GENERAL NOTES
2018 TID NO. 1 INFRASTRUCTURE
TRAIL IMPROVEMENTS
GAYS MILLS, WISCONSIN

PLAN & PROFILE
2018 TID NO. 1 INFRASTRUCTURE
TRAIL IMPROVEMENTS
GAYS MILLS, WISCONSIN

REVISIONS		REVISIONS		SCALE AS SHOWN
NO.	DATE	NO.	DATE	
SCALE				AS SHOWN
DATE				
JULY 2018				
DRAFTER				
PJUN				
CHECKED				
MMUC				
PROJECT NO.				
180089				
SHEET				
5 OF 24				
DWG. NO.

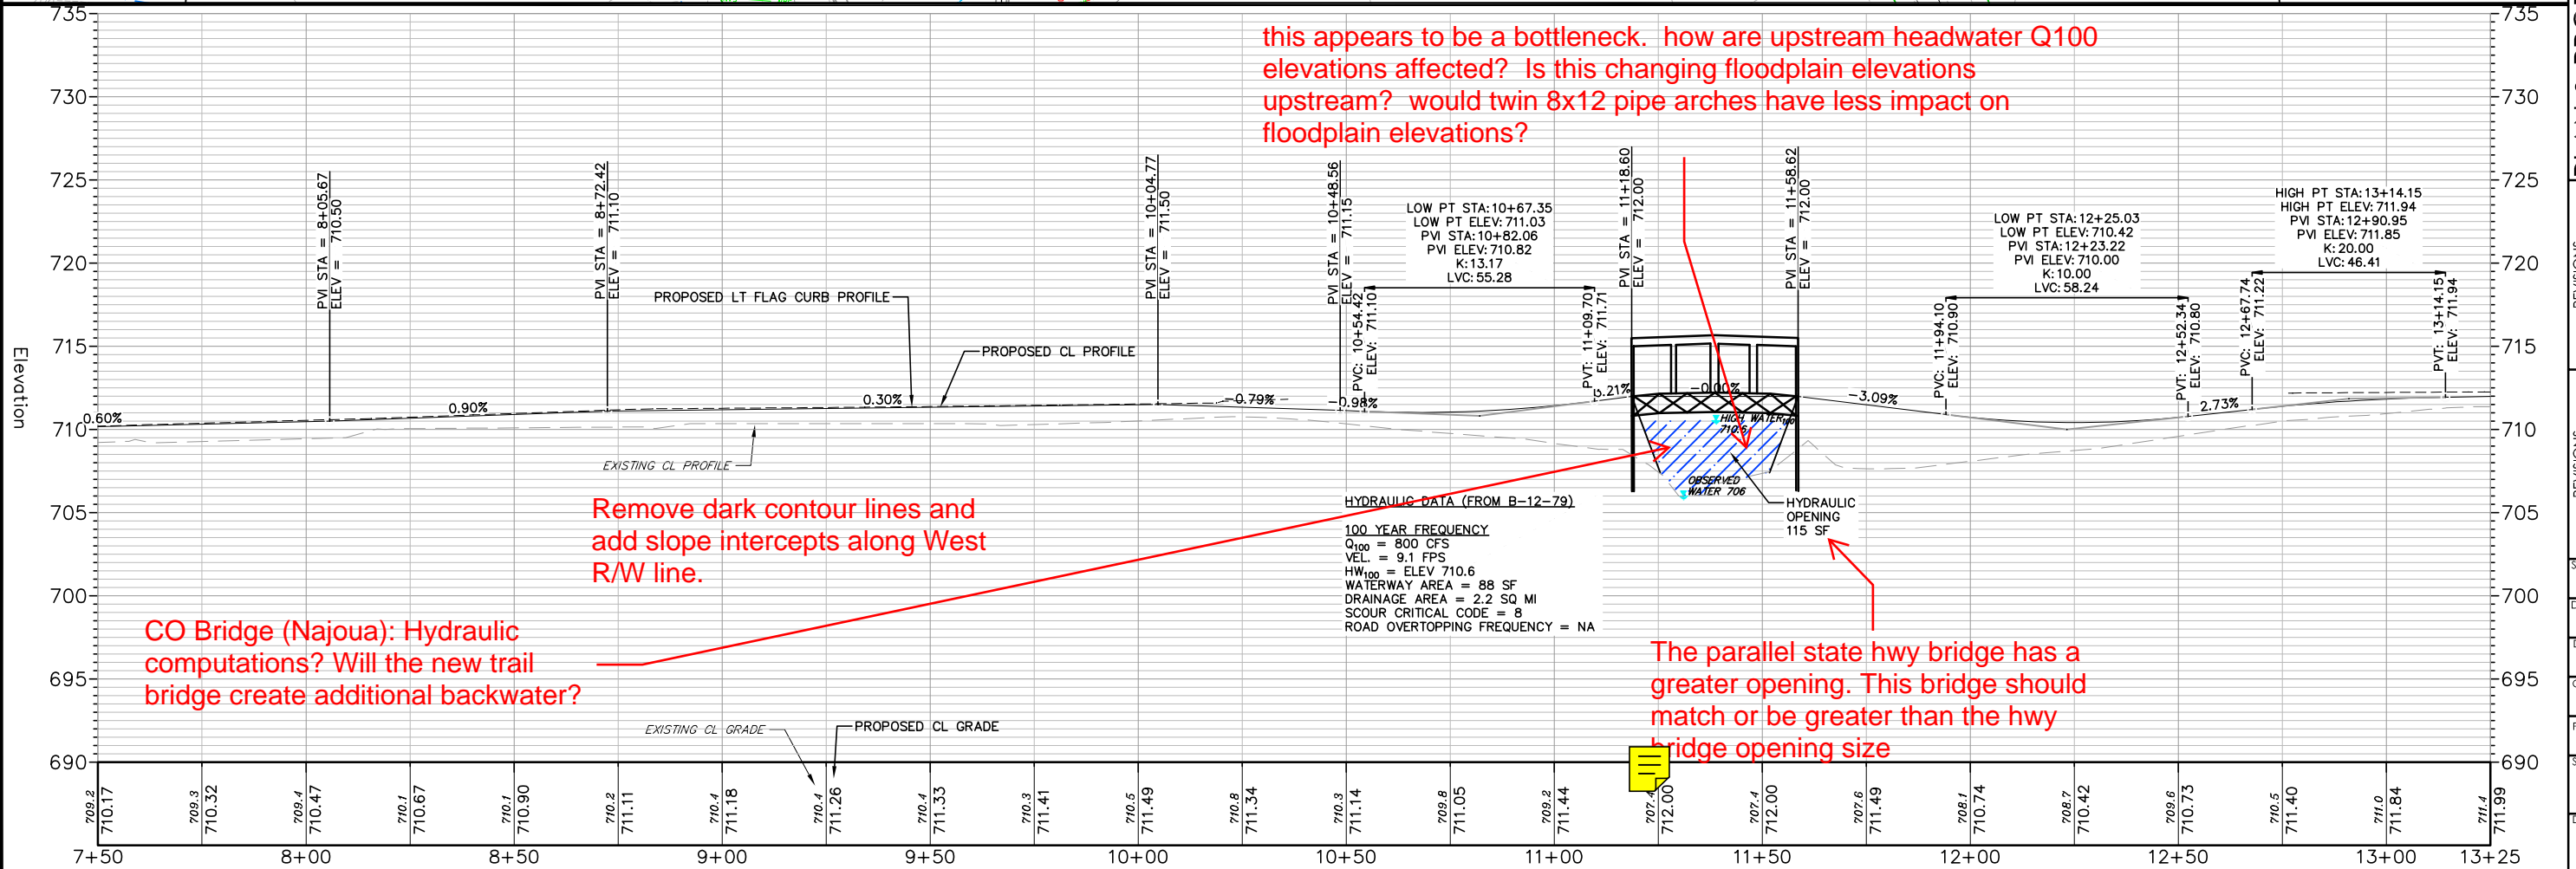
Provide all permits/coordination with DNR, Corp, applications/permits

Concerns over chain link fence, location and how it may impact the operations of the WIS 131 beamguard if hit (deflection distance)?

this appears to be a bottleneck. how are upstream headwater Q100 elevations affected? Is this changing floodplain elevations upstream? would twin 8x12 pipe arches have less impact on floodplain elevations?

Remove dark contour lines and add slope intercepts along West R/W line.

CO Bridge (Najoua): Hydraulic computations? Will the new trail bridge create additional backwater?

The parallel state hwy bridge has a greater opening. This bridge should match or be greater than the hwy bridge opening size

working width (deflection) of guardrail is 5' from front face of rail (3' between back of post to fence). should be ok based on scale.

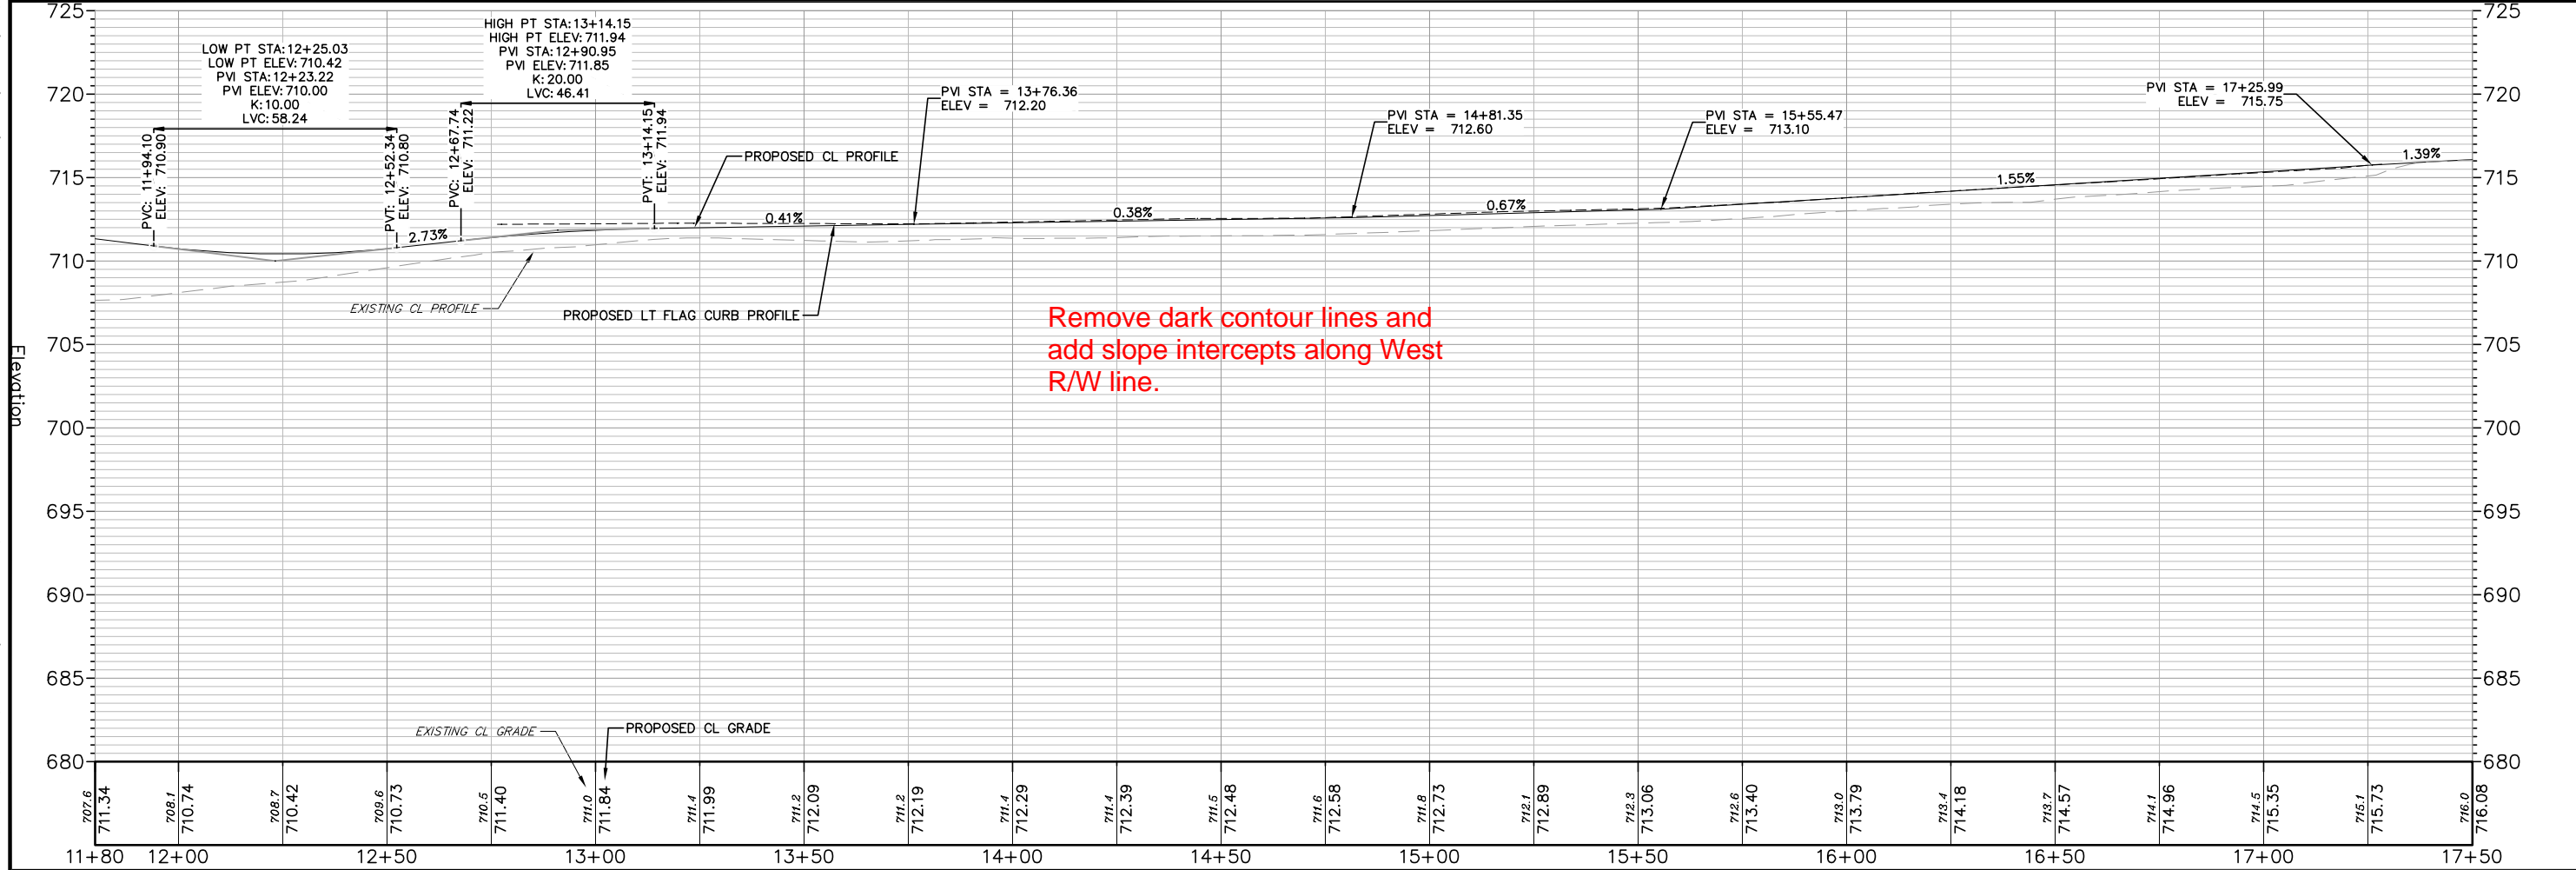
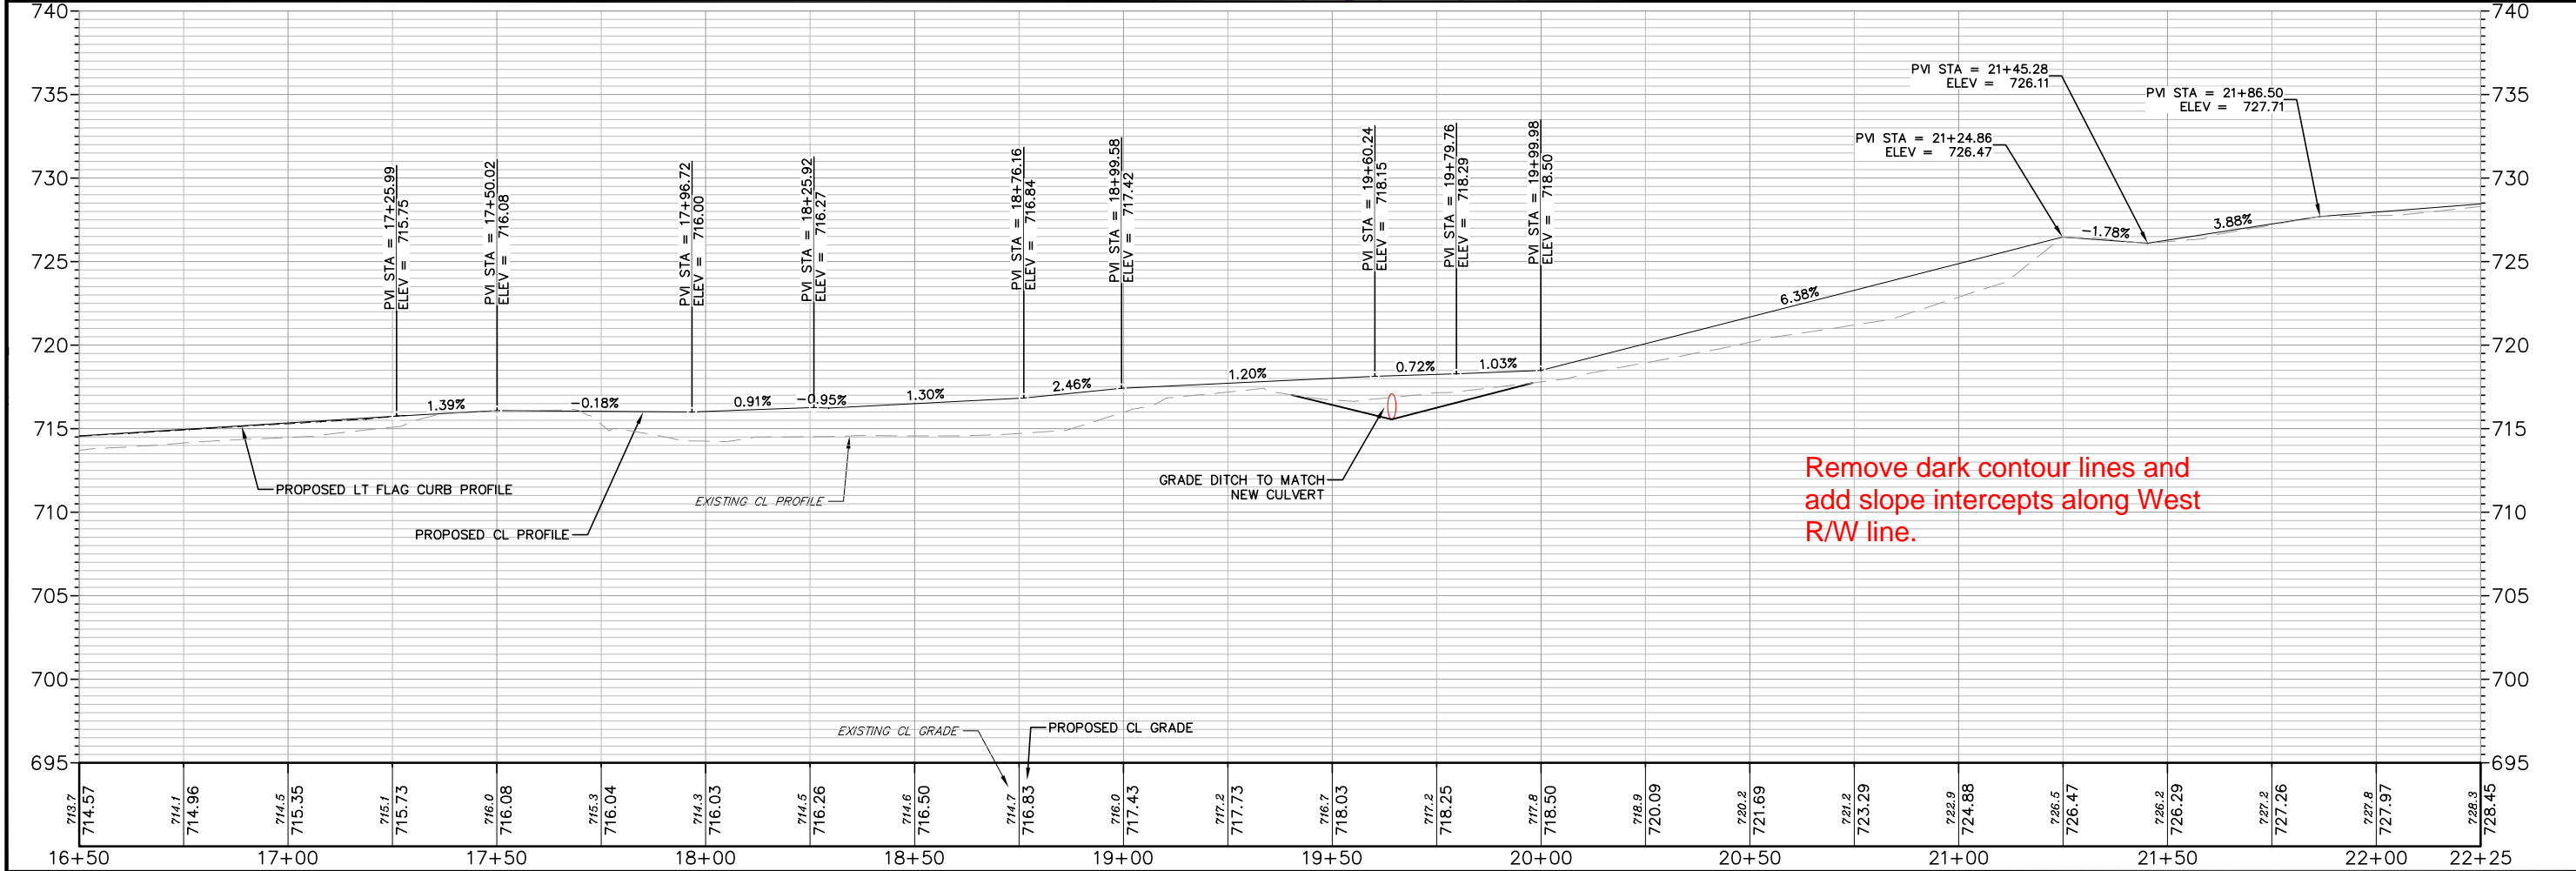
Remove dark contour lines and add slope intercepts along West R/W line.

SCALE AS SHOWN		REVISIONS		REVISIONS	
DATE JULY, 2018		NO.	DATE	NO.	DATE
DRAFTER PJUN					
CHECKED MMUC					
PROJECT NO. 180089					
SHEET 13 OF 24					
DWG. NO.

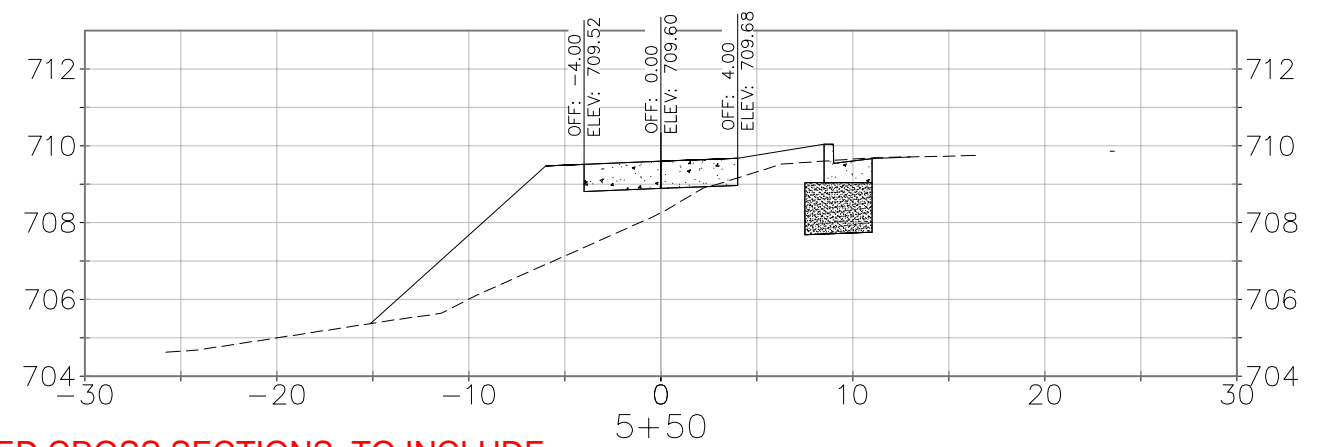
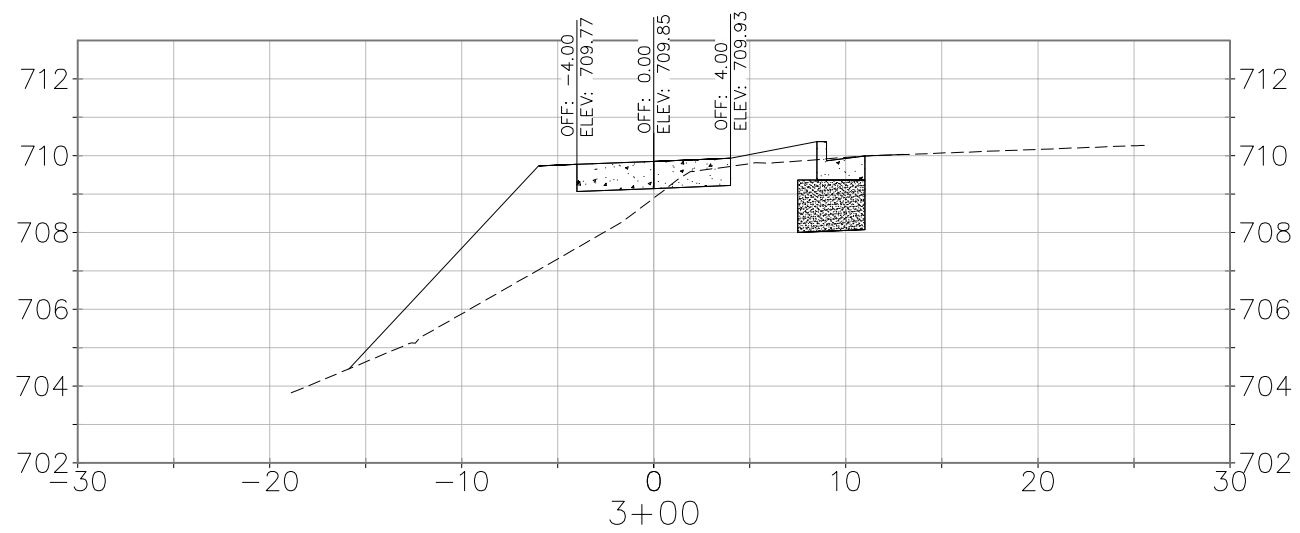
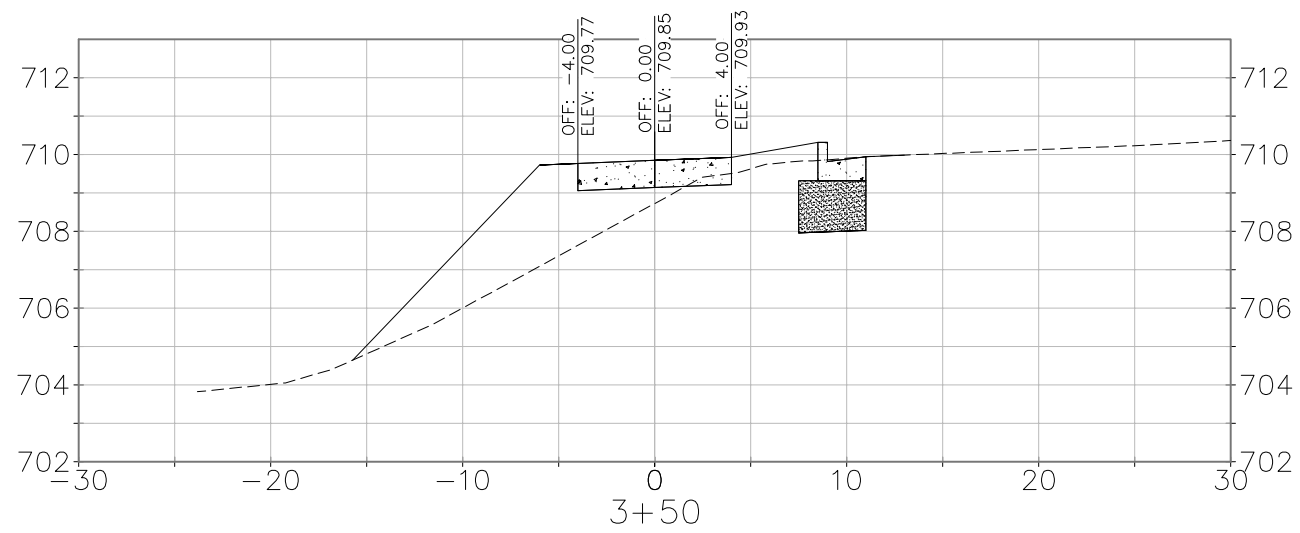
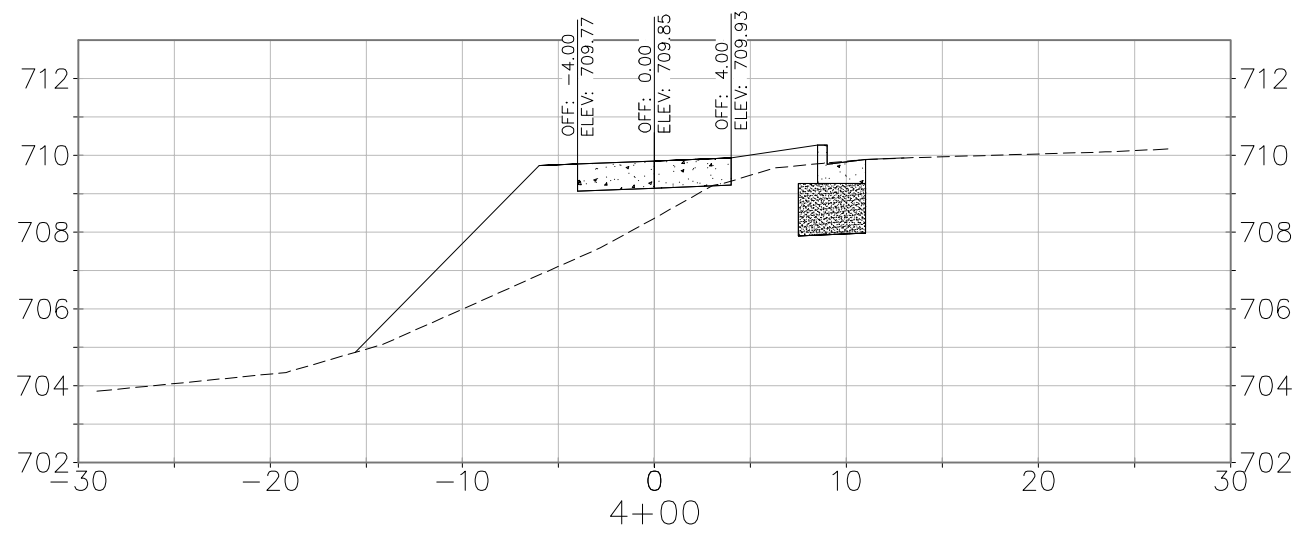
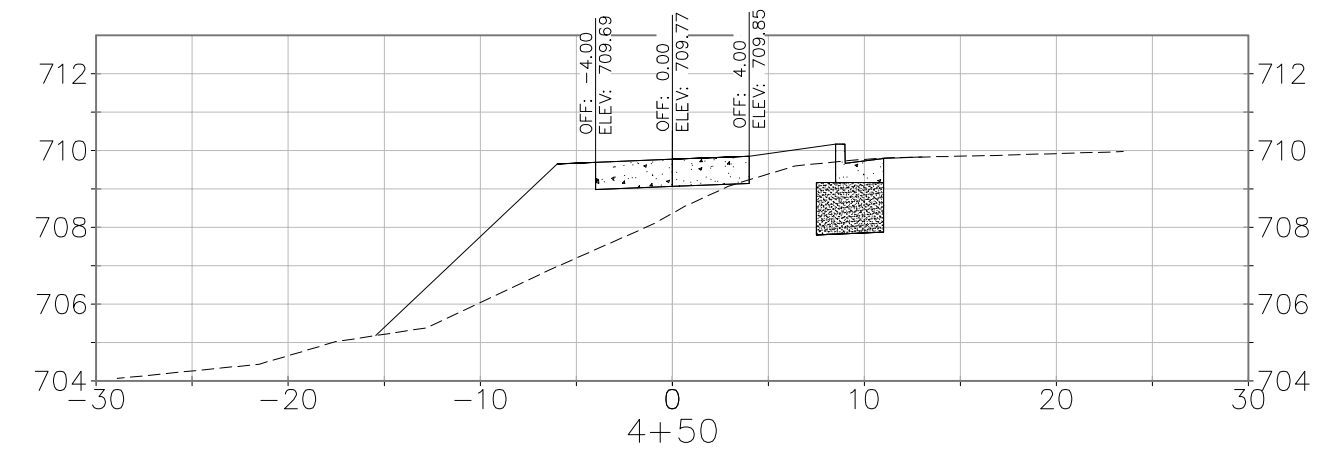
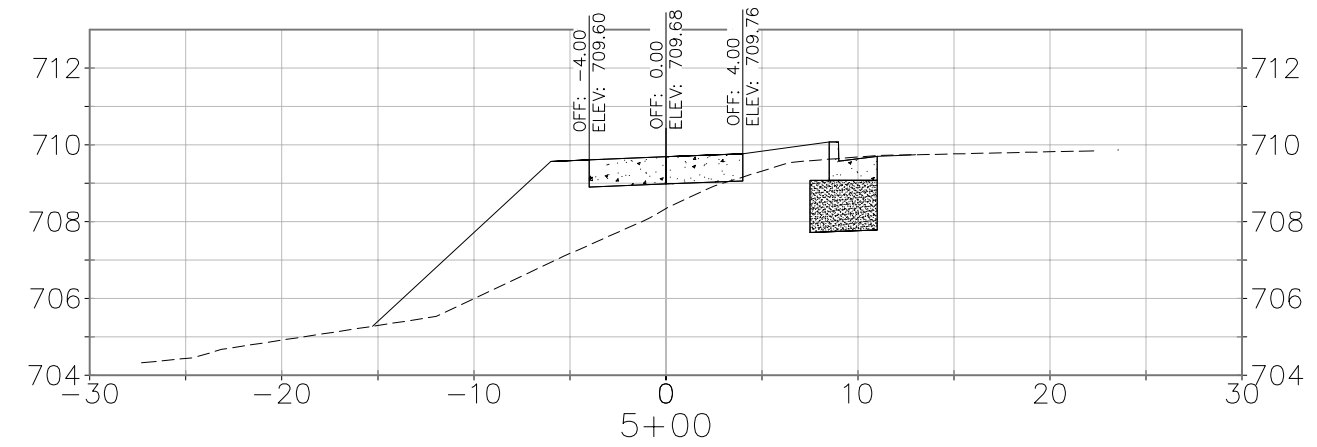
NEED CROSS SECTIONS TO INCLUDE:
slope intercept offset/elevations; right of
way lines and utilities
